STERLING RANCH FILING NO. 2

FINAL PLAT

FILE NO. SF-18-20

PLat V_1 planning only.pdf Markup Summary

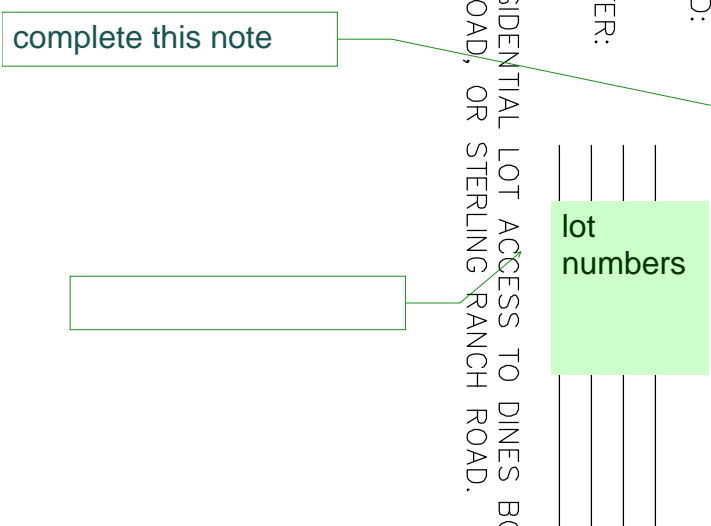
delete park and openspace from this note

this is different than easement detail

flee numbers

no basements? underdrains who maintains add notes please

complete this note

is this going into a PID?add note..

noise wall detail and mitigation note by who and maintained by whom

FINAL PLAT
STERLING RANCH FILING NO. 2
JOB NO. 25188.01
05/14/2020
SHEET 3 OF 6
FILE NO. SF-18-20

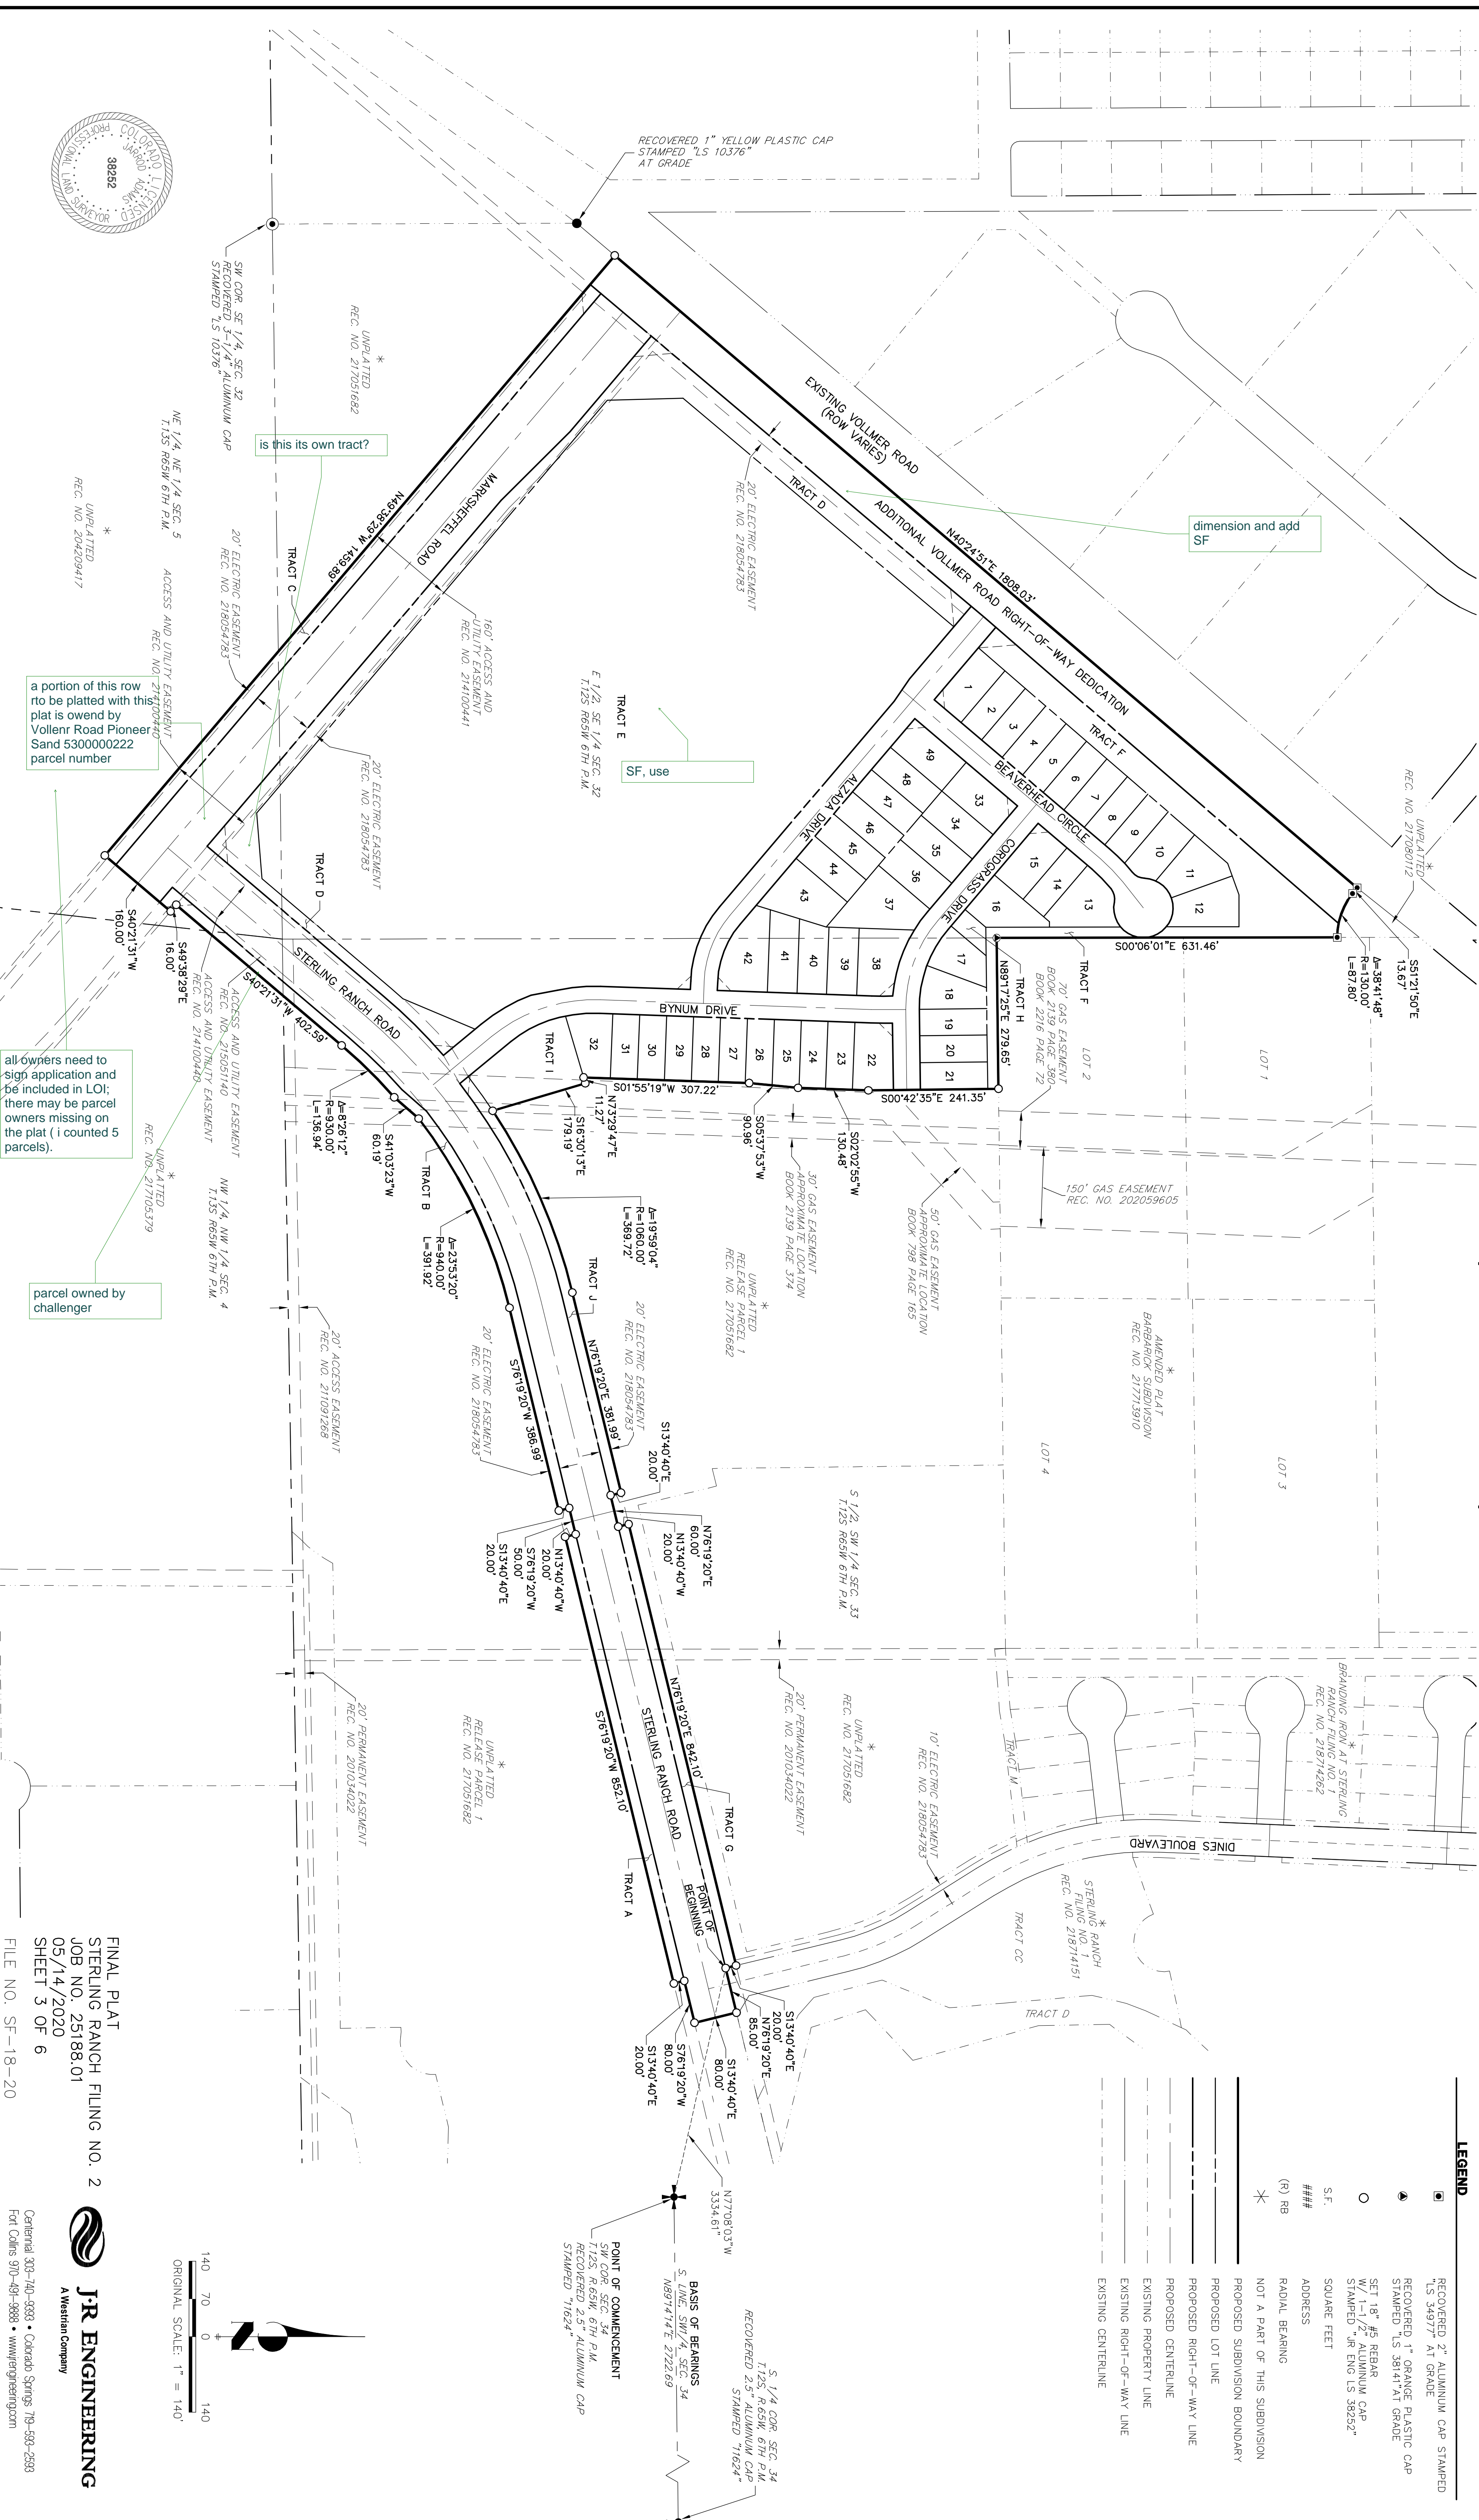
all owners need to sign application and be included in LOI; there may be parcel owners missing on the plat (I counted 5 parcels).

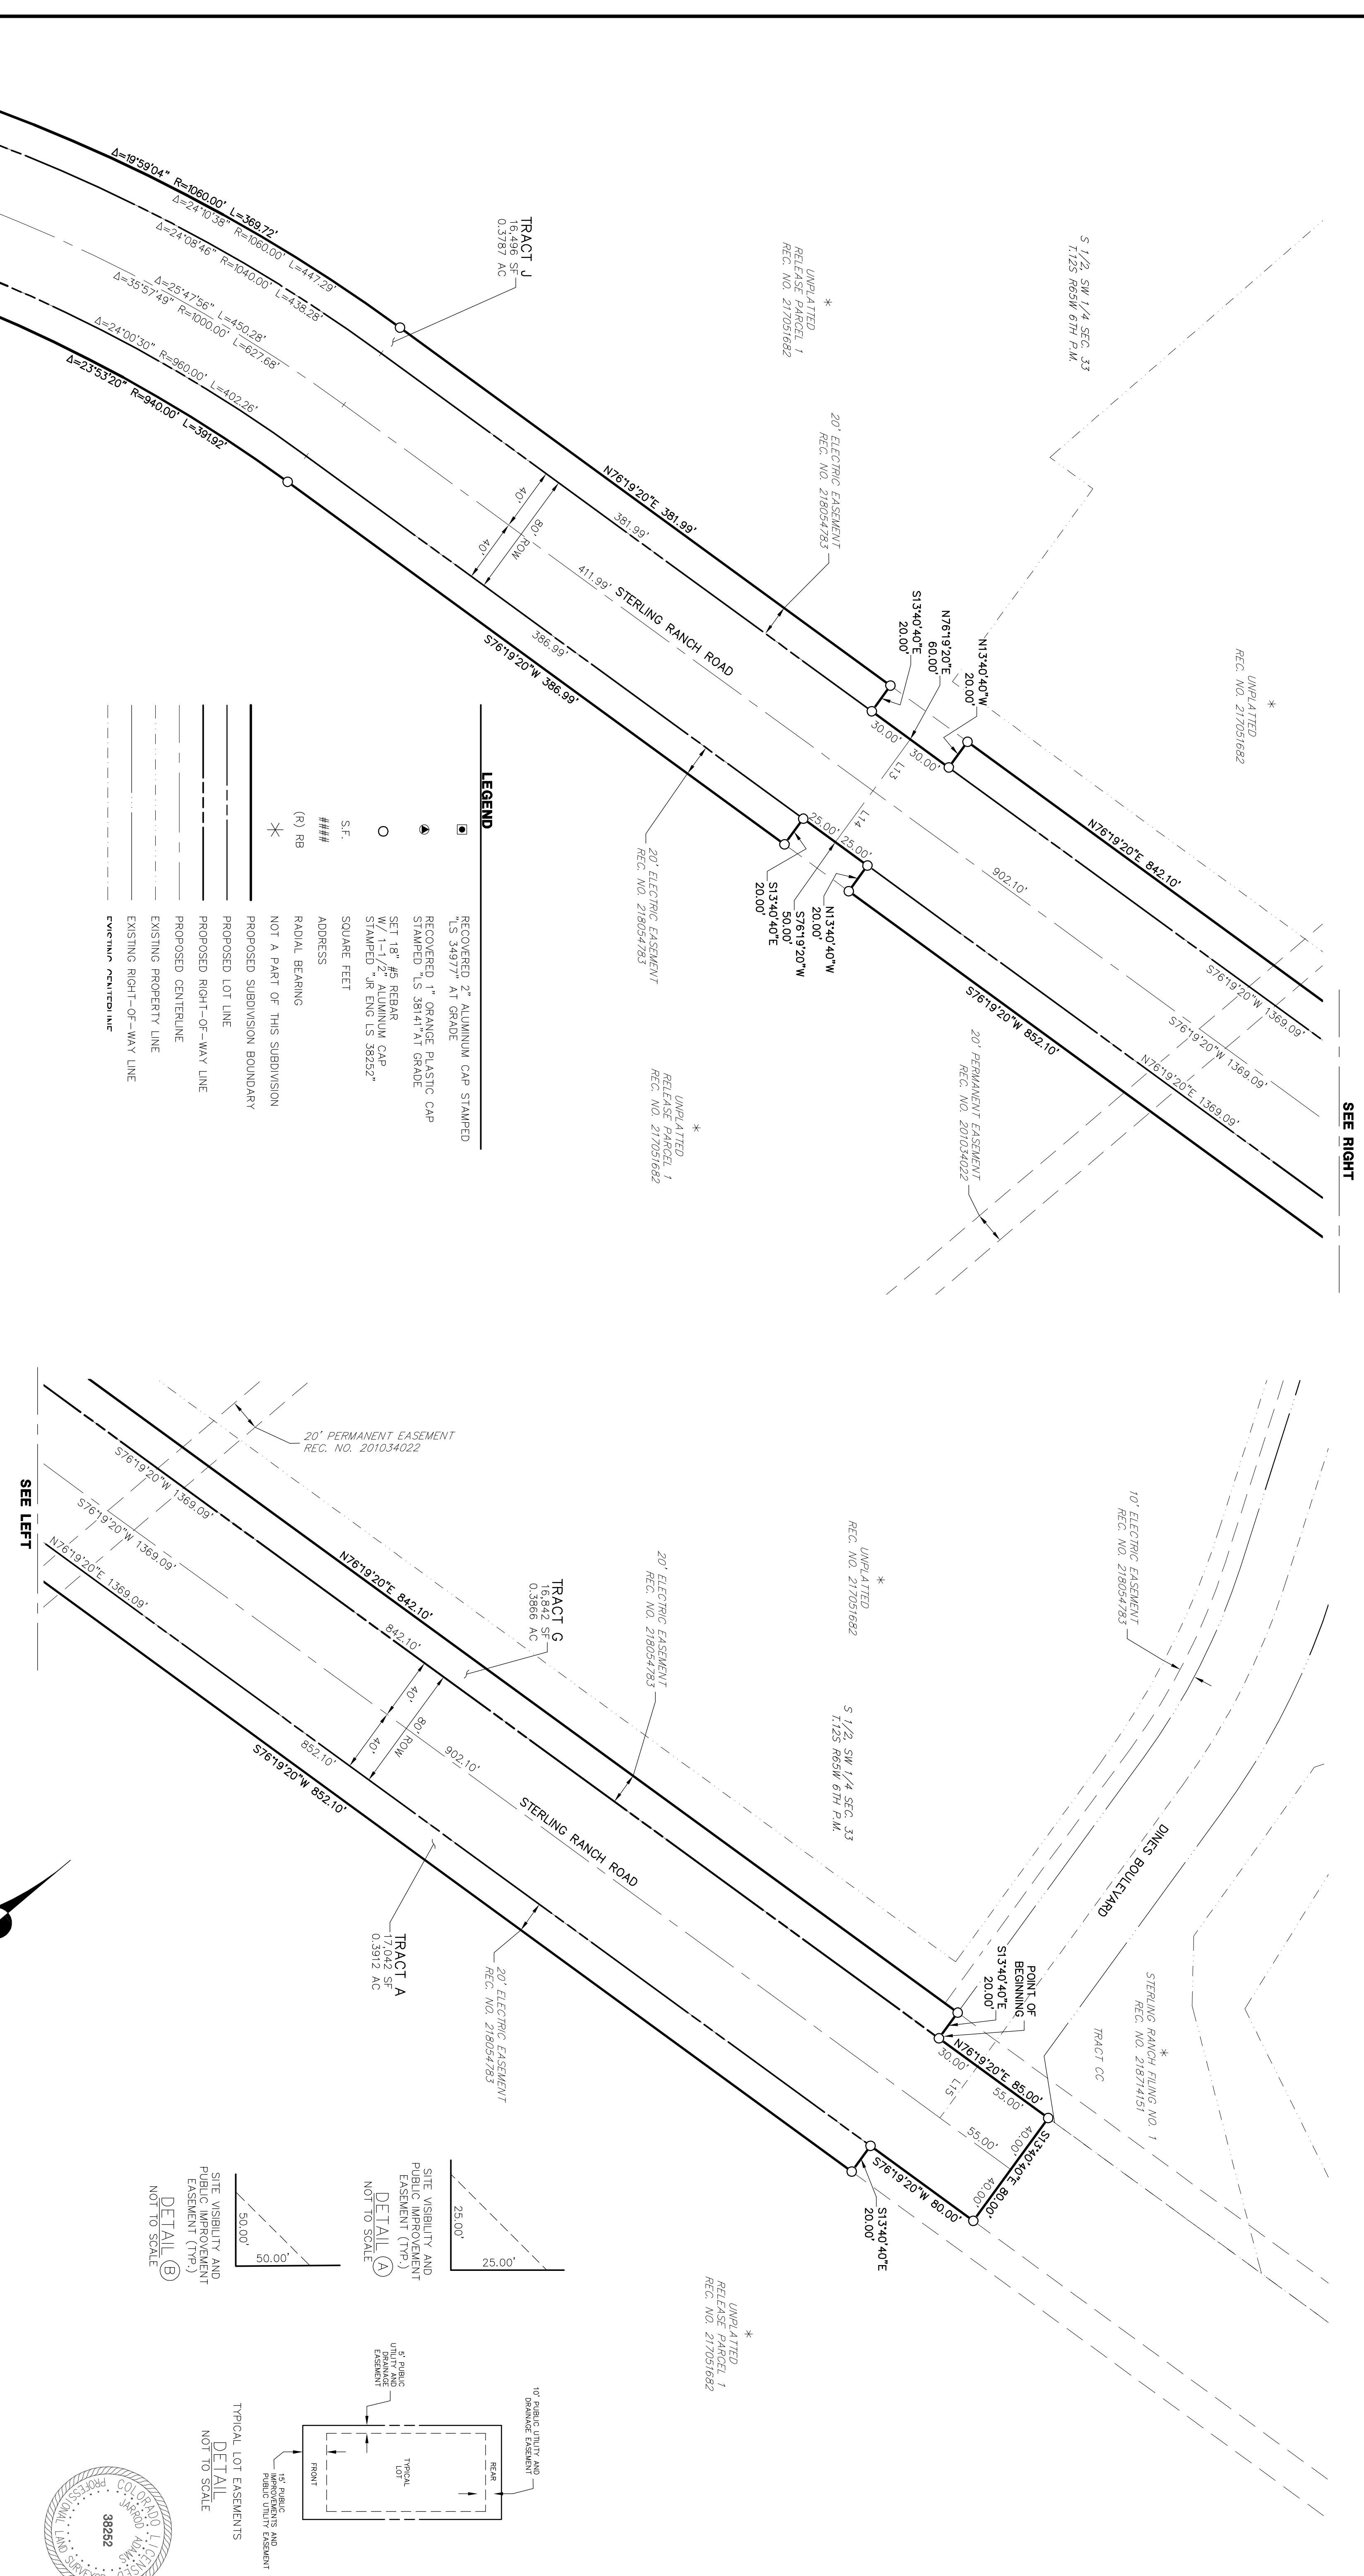
parcel owned by challenger

a portion of this row to be platted with this plat is owned by Vollmer Road Pioneer Sand 5300000222 parcel number

is this its own tract?

dimension and add SF
